ADDENDUM #2

PROJECT: Bridge Classroom Portable & Relocated Portable at Lawrence ES
Lodi Unified School District

REF. # : District Project No. #2600-5870-210-60
DSA FILE # 39-50
Lawrence ES

DATE : January 21, 2026

SIGNAL PLANS

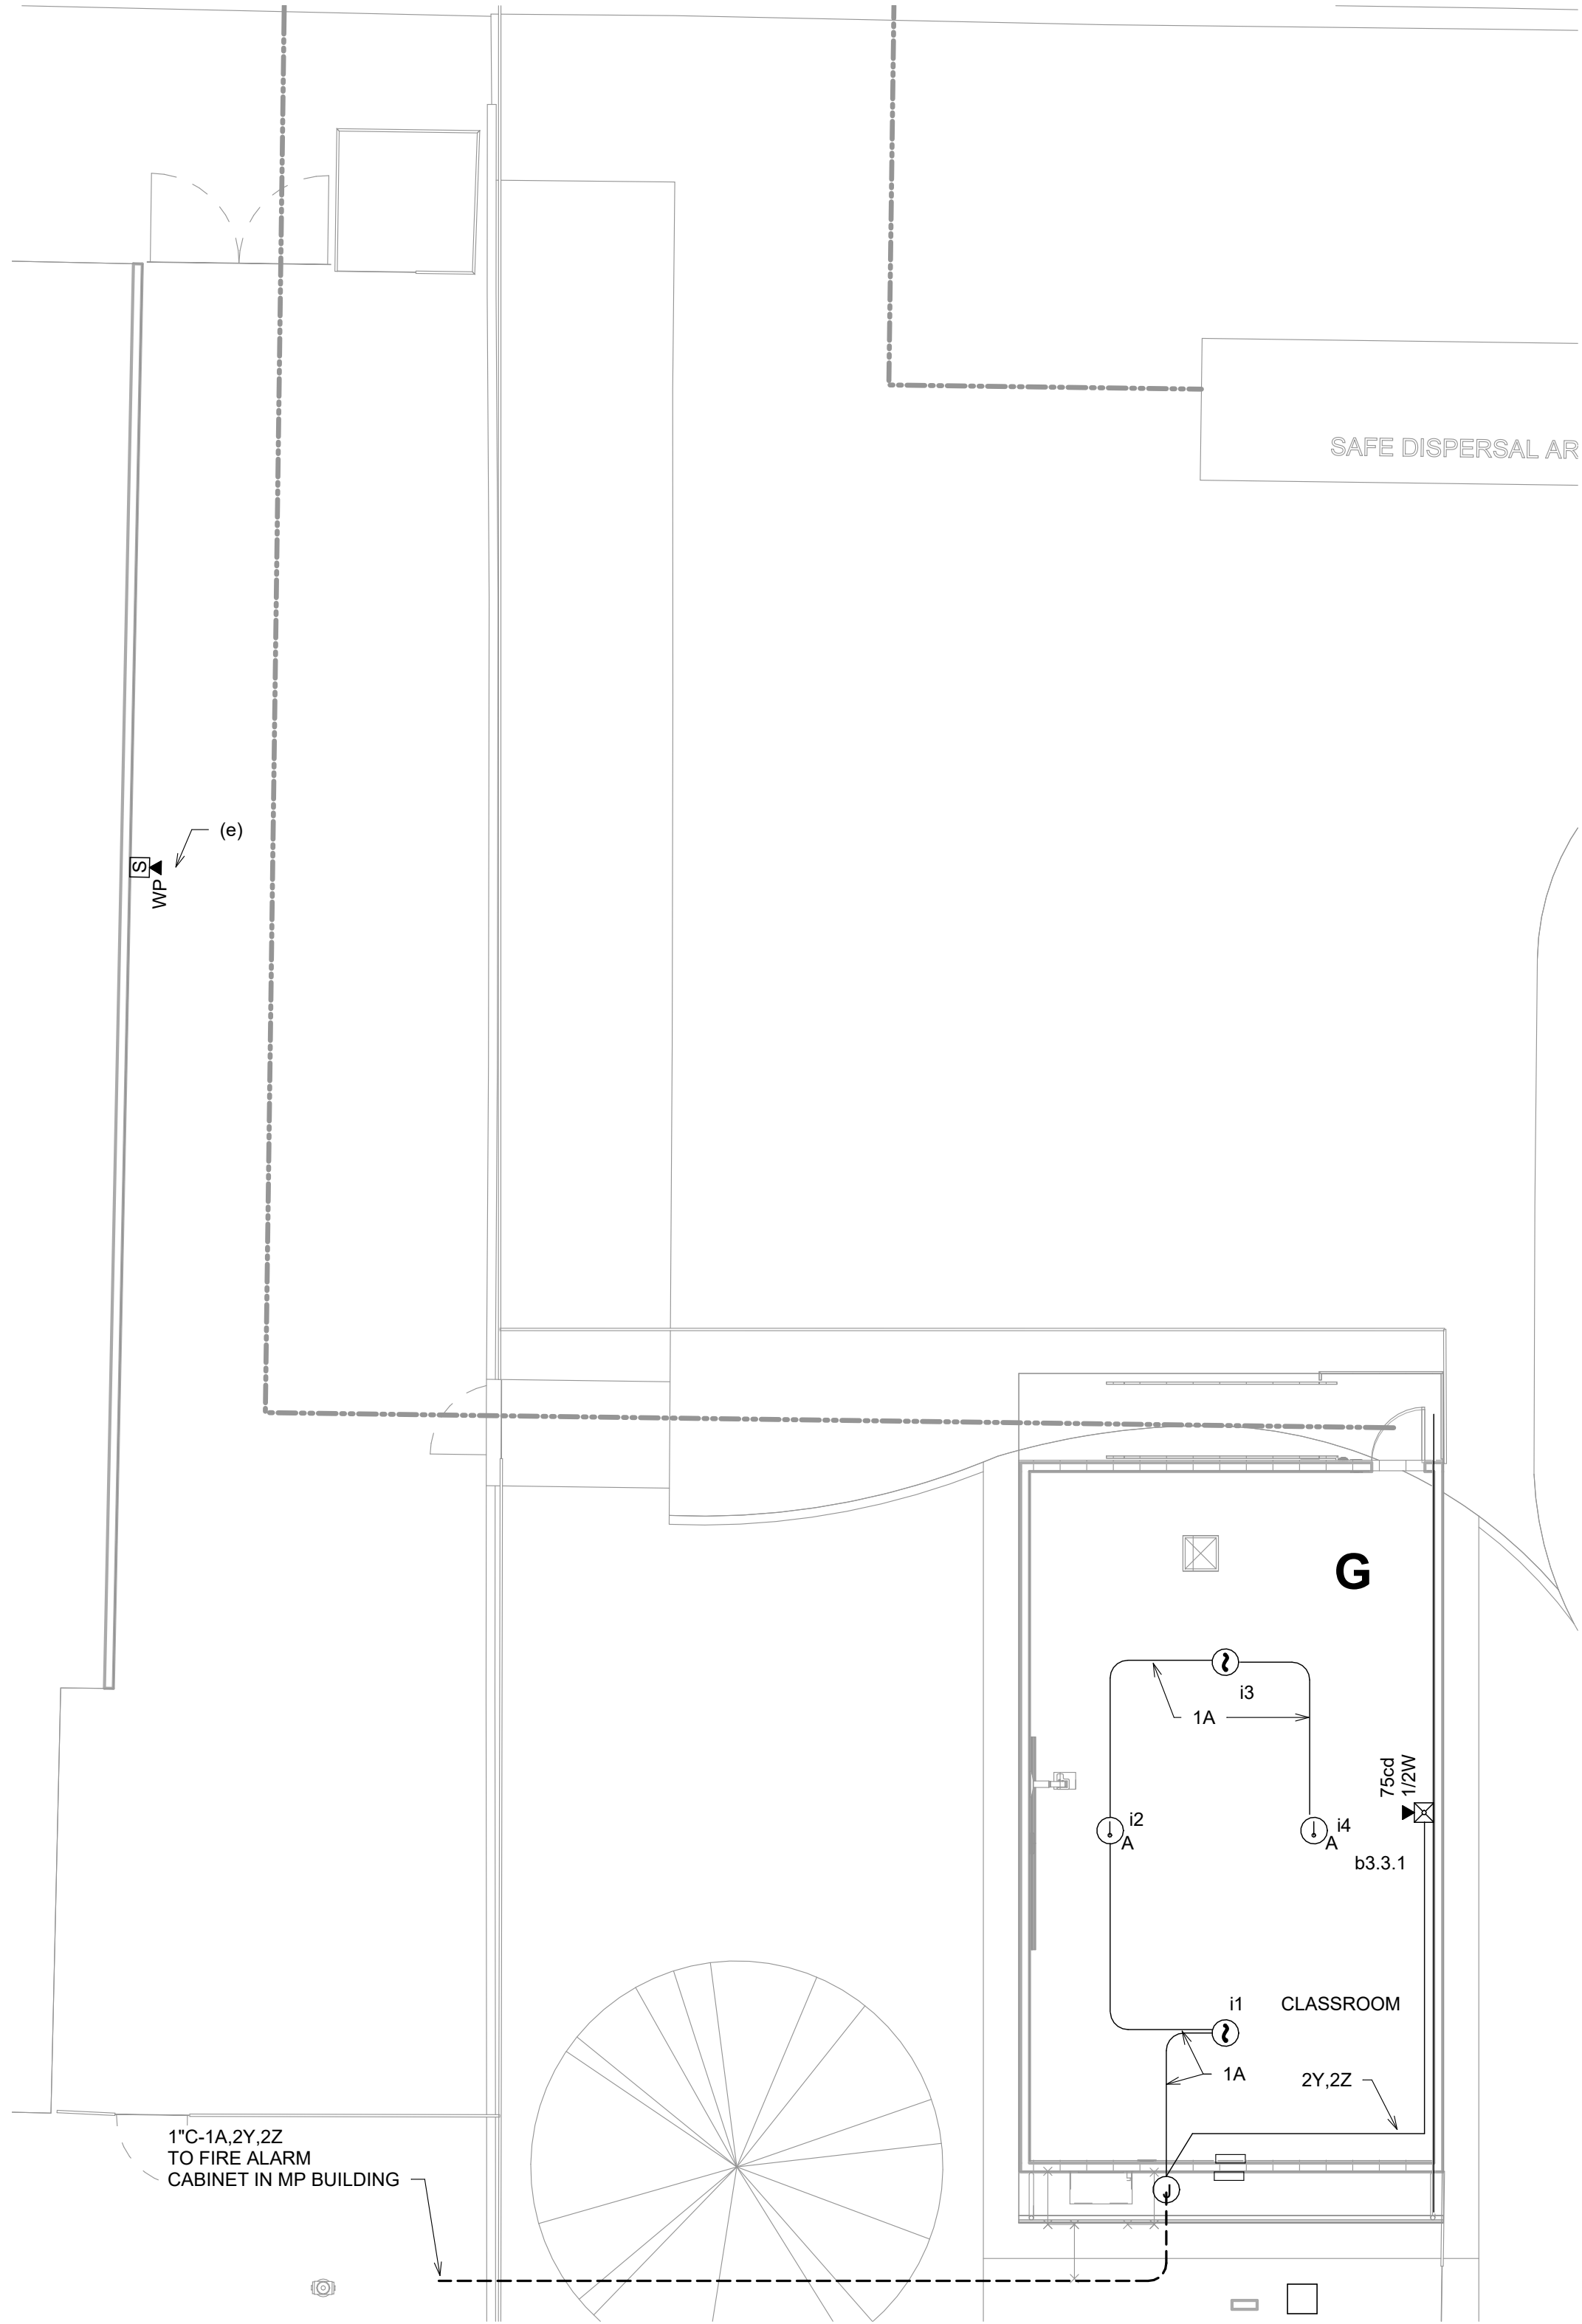
ITEM 1 Provide CAT 6A wiring for phones, data, and intercom systems

All wiring used in the Bridge Portable Classroom building (Unit G) and Relocated Portable (Unit H) at Lawrence Elementary School projects are to be CAT 6A wiring as described on the attached revised sheets 1-ES1.1 and 1-ES2.1 of the DSA approved drawings #02-123434 and #02-123755. Contractor to provide wiring and connections of phone, data, and intercom systems to each building. The District will provide and install the Jive phone/intercom system.

SHEET NOTES	
SN.03	PROVIDE (1) CAT6A FOR WIRELESS ACCESS POINT
SN.04	PROVIDE SURFACE MOUNT CLOCKSPEAKER TO MATCH THE EXISTING SYSTEM, MOUNT AT 84" TO TOP. PREWIRE WITH CAT 6A CABLES THROUGH EXISTING CONDUITS TO IDF FOR SPEAKER. CLOCK TO BE BATTERY POWERED AND INSTALLED BY THE DISTRICT. PROVIDE ACCESSORIES AND PROGRAMMING AS REQUIRED.
